Access Compliance Report Public Rights-of-Way (Curb Ramps)

Main Street: N/A		Cross Street: LAMBERT_RD		Location: N	
ADA ID: RPRK220201123241	Ramp Type: Type 6 - Directional 1	Initial Pass/Fail: Pass	Overall Compliance: No	Severity Score: 10	
Codes/Mitigation Info/Possible Solution			Field Measurements/Component Compliance

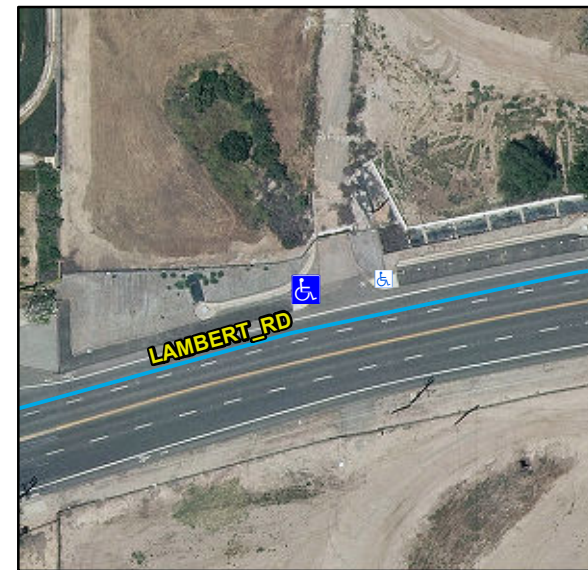
Compliance	Description	Data	Compliance	Description	Data
N/A	Ramp Length (in)	140	N/A	Flare Type LT	
Yes	Ramp Width (in)	65			Sloped
Yes	Ramp Run Slope (%)	6.6	Yes	Flare Slope LT (%)	5.9
Yes	Ramp Cross Slope (%)	0.5	N/A	Flare Traversable LT	Yes
Yes	Grade Break	Yes	Yes	Flare Type RT	
Yes	Grade Break Slope (%)	0.8			Curbed2
Yes	Grade Break Cross Slope (%)	0.8	N/A	Flare Slope RT (%)	N/A
	Addl Para Ramp Left?	No	N/A	Flare Traversable RT	N/A
	Addl Para Ramp Right?	No	Yes	DWS Provided	Yes
N/A	Landing Present	No	Yes	DWS Contrast	Yes
No	Landing Length (in)	N/A	Yes	DWS Length (in)	80
No	Landing Width (in)	N/A	Yes	DWS Full Width	Yes
No	Landing Run Slope (%)	N/A		DWS Offset Type	Single
No	Landing Cross Slope (%)	N/A	Yes	DWS Left Offset (in)	0
N/A	Landing Movement Obstructed?	No	N/A	DWS Right Offset (in)	0
	Landing Movement Type	N/A			
N/A	Landing Shared	N/A			
N/A	Marked Crosswalk 1	No	N/A	Clear Space	N/A
	Crossing 1 Direction	E	N/A	Clear Space To Crosswalk (in)	N/A

N/A	Marked Crosswalk 1 Width (in)	N/A			
N/A	Ramp Inside Crosswalk 1	N/A			
	Crossing 1 Slope (%)	3.7			
	Crossing 1 Cross Slope (%)	0.8			
No	Gutter Ponding	Yes	Yes	Curb Slope	3.7
Yes	Gutter Lip Height (in)	0		Road Run Slope (%)	N/A
Yes	Gutter Run Slope (%)	3.7		Road Cross Slope (%)	N/A
No	Gutter Cross Slope (%)	2.2		Parallel Ramp Side	Right
Yes	Overall Surface Condition	Acceptable	Yes	Perp Joint Present	Yes
	Cross Gutter Present?	No		Spandrel Present?	No
	Replace Cross Gutter?	N/A		Replace Spandrel?	N/A

Install Landing. Remove & Replace Gutter.
